# Interactive comment on “Climate change effects on the hydrology of the headwaters of the Tagus River: implications for the management of the Tagus-Segura transfer” by Francisco Pellicer-Martínez and José Miguel Martínez-Paz

## Anonymous Referee #1

Received and published: 2 July 2018

**Fig. 2.** Operating rule of the TSA. Based on BOE (2014; 2015).

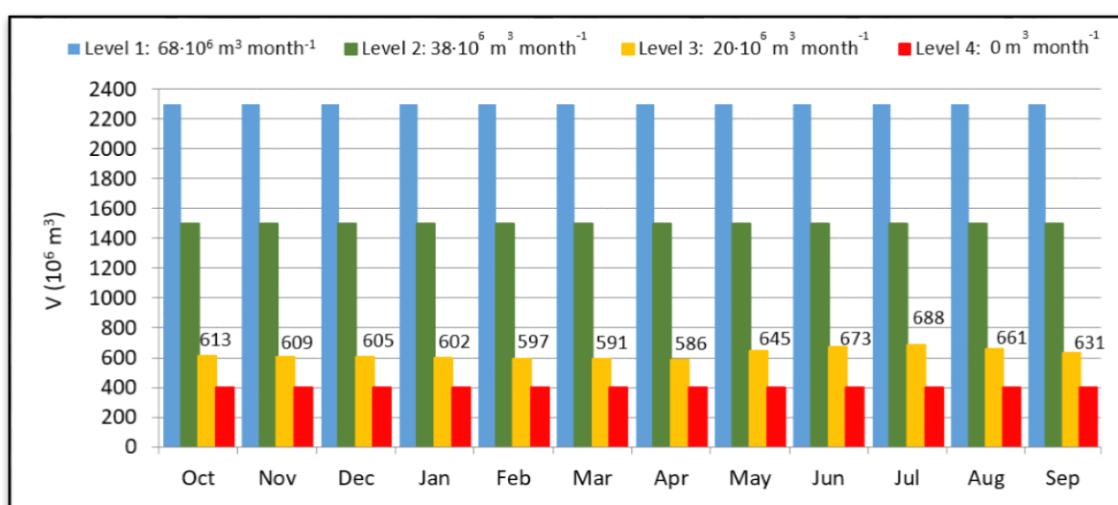
Page 4, Line 13 - Page 5, Line 11: "The operating rule (Fig. 2) basically consists of two conditioning factors (BOE, 2014)". The considered operating rule (BOE, 2014) is no longer in force, because the most recent one was included in Law 21/2015.

Thanks for this key contribution. We have included the new data in the model that simulates the Tagus Headwaters Water Resources Exploitation System (THWRES). The changes are:

- The accumulated volume in the reservoirs Vacu, that previously was  $1300 \times 10^6 \text{ m}^3$  in the BOE (2014) has been changed by  $1500 \times 10^6 \text{ m}^3$  (BOE, 2015). This affects to the levels 1 and 2.
- The flows that enter in the reservoirs EBR (Aacu) during a year decrease to  $1000 \times 10^6 \text{ m}^3$  (before was  $1200 \times 10^6 \text{ m}^3$  in BOE (2014)). This affects to the levels 1 and 2.

- In addition, the maximum volume that can be transferred in one month at the level 1 increases to  $68 \cdot 10^6 \text{ m}^3$  (previously  $60 \cdot 10^6 \text{ m}^3$  in BOE (2014)).

The rest of the conditions remain the same.

Therefore, on the one hand the operating rule is more restrictive, increasing the accumulated volume in the reservoirs for the maximum flow transferred in one month. But, on the other hand the operating rule is less restrictive diminishing the condition of the flows that enter in the reservoirs, and increasing the maximum volume that can be transferred in one month (level 1).

So, the three scenarios have been modeled again with the updated operating rule and the transferred volumes increase slightly in all of them. This leads to slight changes in the figures of the part of results "section 5.2" and in the part of the socioeconomic study of the "6. Discussion". The economic figures of the abstract are also changed. Now the economic losses are between "*380-425 million €*" (in the previous version are between 330-380 million €).

*The four levels are:*

- *Level 4. When  $V_{acu}$  is lower than  $400 \cdot 10^6 \text{ m}^3$ . Transfers are not allowed ( $Q_{trans} = 0 \text{ m}^3/\text{month}$ ).*
- *Level 3. When  $V_{acu}$  is between  $400 \cdot 10^6 \text{ m}^3$  and the values indicated in Fig. 2, which vary between  $586 \cdot 10^6 \text{ m}^3$  and  $688 \cdot 10^6 \text{ m}^3$  depending on the month. Transfers ( $Q_{trans}$ ) of  $20 \cdot 10^6 \text{ m}^3/\text{month}$  are allowed.*

- *Level 2. When  $V_{acu}$  is between the volumes established in Level 3 and  $1500 \cdot 10^6 \text{ m}^3$ , and in addition  $A_{acu}$  is lower than  $1000 \cdot 10^6 \text{ m}^3$ . Transfers ( $Q_{trans}$ ) of  $38 \cdot 10^6 \text{ m}^3/\text{month}$  are allowed.*

- *Level 1. When  $V_{acu}$  is equal to or greater than  $1500 \cdot 10^6 \text{ m}^3$ , or  $A_{acu}$  is equal to or greater than  $1000 \cdot 10^6 \text{ m}^3$ . Transfers ( $Q_{trans}$ ) of  $68 \cdot 10^6 \text{ m}^3/\text{month}$  are allowed.*
